< Guangdong Qianyan Technology Co., Ltd. >

Declaration of Product Modifications

This is to request a Class II permissive change for FCC ID: 2A7VD-H8120 originally granted on 08/28/2025.

Figure 1. Power Board Change Point Comparison

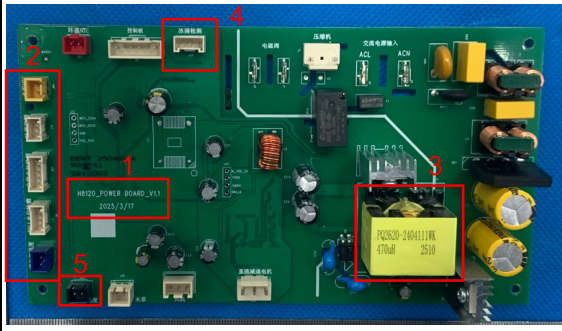
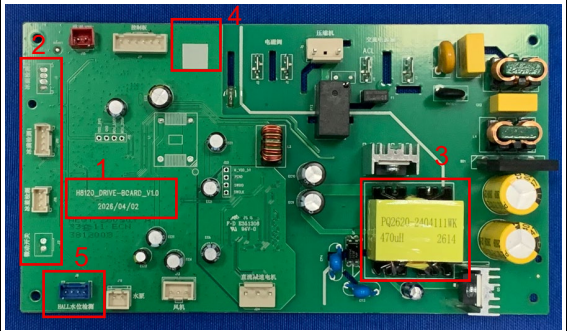
1. PCB silkscreen / version marking: old board: H8120_DRIVE-B-CARD_V1.0(2026/04/02); new board: H8120_POWERBOARD_V1.1(2025/3/17). 2. Extra left—side connectors (old board only): old board: has additional connectors along the left edge; new board: does not have these connectors. 3. Transformer marking: old board: “PQ2620-2404111WK 470uH 2510”; new board: “PQ2620-2404111WK 470uH2614”. 4. The new board features an additional 4-pin socket connector. 5. The number of pins on the socket connectors differs: The old board has a 2-pin socket connector, while the new board has a 4-pin socket connector.
